# UNITED STATES PATENT AND TRADEMARK OFFICE

APPLICATION NO.	FILING DATE	FIRST NAMED INVENTOR	ATTORNEY DOCKET NO.	CONFIRMATION NO.
10/679,421	10/07/2003	Michio Masuda	TOC-0008	3476

**Office Action Summary**

## **DETAILED ACTION**

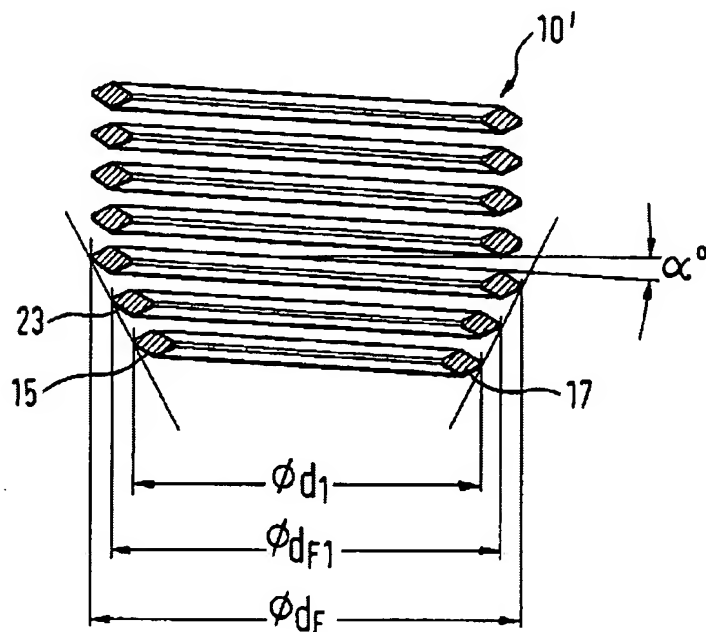
3. Claim 1 is rejected under 35 U.S.C. 102(b) as being anticipated by Kobusch UP 6146073.

Kobusch teaches a spiral coil shaped insertion body formed by coiling a rhombic cross-section wire (Fig 2 or 5) and attached to a female screw of a flexible material, the spiral body comprising:

- a cylinder portion of fixed diameter (straight portion formed by top 5 threads above)
- a taper portion with outside diameter reduced from cylinder portion toward distal end of spiral body (tapered portion formed by bottom 3 threads above)
- the outside thread pitch diameter of cylinder section > pitch diameter of the female screw (col 3 lines 1-12, col 4 lines 7-19)
- the inside thread pitch diameter of a region of the taper portion covering 1 or more turns < pitch diameter of a male screw. There is a male screw that is usable with the

coil which has a pitch diameter larger than the inside thread pitch diameter of the taper portion. No male screw limitation is positively recited.
